REMARKS

This application has been reviewed in light of the Office Action dated May 27, 1999. By the present amendment, claims 1, 7, and 17-19 have been amended. Claims 1-5, 7-10, and 16-19 are pending in this application, with claims 1, 7, and 17-19 being in independent form. It is submitted that no new matter has been added by the present amendment.

FIG. 1 (RELATED ART)

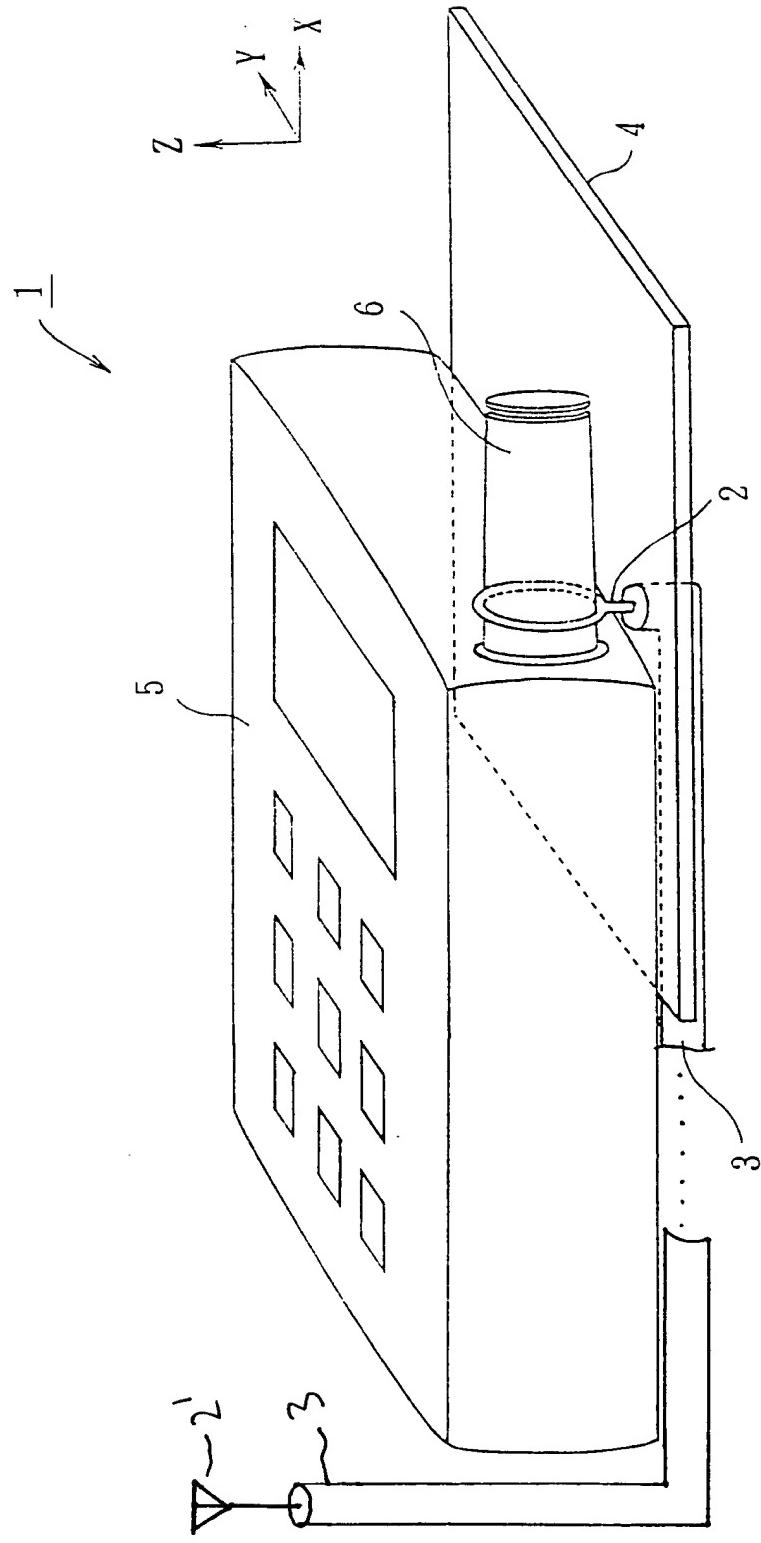
The drawings were objected to under 37 CFR 1.83(a) for failing to show every feature of the invention specified in the claims. Submitted herewith is a Letter With Proposed Drawing Changes in which the second antenna or external antenna is shown in Figs. 1, 4, 11A, and 11B. This antenna is referred to throughout the original specification, as well as in the original claims, so that the proposed showing in the drawing simply conforms to the original specification and claims. Thus, it is respectfully submitted that the changes involve no new matter. It is also proposed to amend

the specification to refer to the second antenna or external antenna as " 2' ", as shown in amended Figs. 1, 4, 11A, and 11B. Withdrawal of the objection is respectfully requested.

Reconsideration is respectfully requested of the rejection of claims 1 and 4 under 35 U.S.C. 102(b), as being anticipated by the Prior Art shown in Fig. 1.

The prior art shown in Fig. 1 relates to an antenna coupling apparatus 1 comprising a ring-shaped electromagnetic coupling element 2 and a transmission cable 3. The electromagnetic coupling element 2 is connected to the core of the transmission cable 3 and to a ground conductor 4 through a nonconducting member. The antenna 6 disposed on a portable radio terminal 5 such as a portable phone is inserted into the electromagnetic coupling element 2.

The prior art of Fig. 1 does not show a reflective ground element, as shown, for example, in Fig. 4 referenced by numeral 21. The reflective ground element reflects some of the power unnecessarily emitted from the antenna connected to the portable radio terminal toward the electromagnetic coupling element. Therefore, unnecessarily emitted power and transmission loss are reduced, compared with conventional portable radio terminals, such as the one shown in Fig. 1.
